PIC16C774 Rev. B Silicon Errata Sheet

The PIC16C774 (Rev. B) parts you have received conform functionally to the Device Data Sheet (DS30275A), except for the anomalies described below.

FIGURE 15-1: PIC16C773/774 VOLTAGE-FREQUENCY GRAPH, $-40^{\circ}\text{C} \leq T_A \leq +85^{\circ}\text{C}$

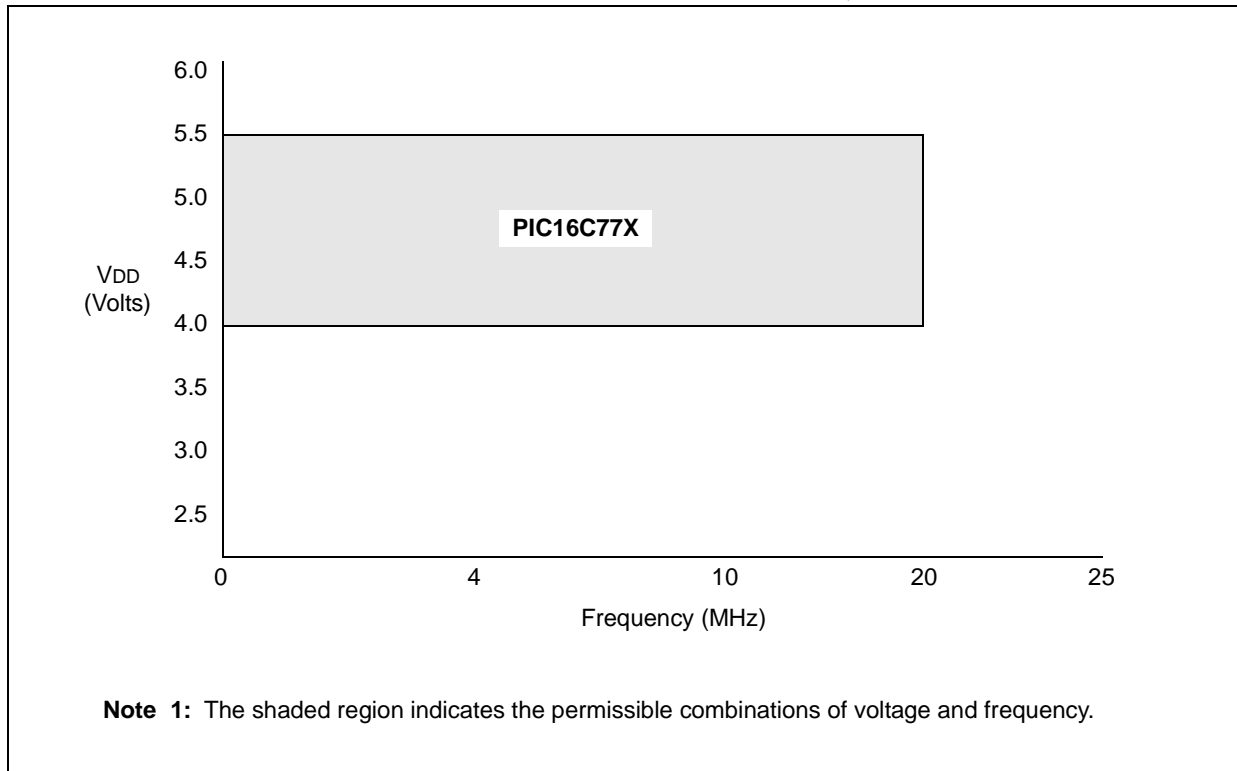
1. Table 15-1 in the Device Data Sheet (DS30275A) should be omitted. Figure 15-1 and Figure 15-2 below should be used to determine the operating voltages and frequencies for the devices.

FIGURE 1: A/D CLOCK SOURCE BLOCK DIAGRAM

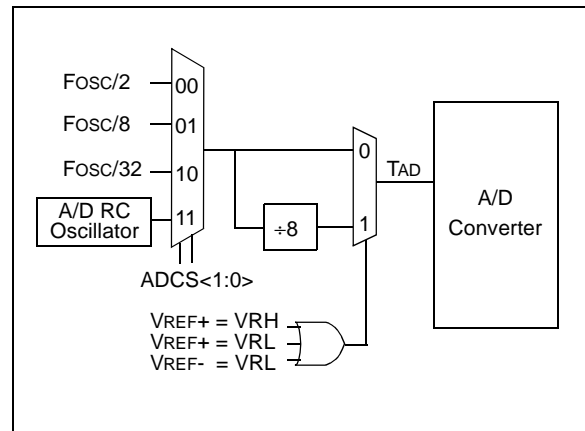
8. The A/D clock source bits (ADCS1:ADCS0) have had their operation modified. See Register 1 for a new definition of the ADCS1 and ADCS0 bits.

Figure 1 shows how the TAD time is determined based upon the selection of the ADCS<1:0> bits and the source of VREF+ and VREF-. When VREF+ or VREF- comes from the internal voltage reference (VRH or VRL), then the required TAD time is increased by a factor of eight (see electrical specification parameter #130A).

The clock source selected by the ADCS<1:0> bits is divided by eight when an internally generated reference voltage is used as reference to the A/D module. This automatically addresses the requirement for the TAD time, when the internal voltage reference is used as the A/D voltage reference.
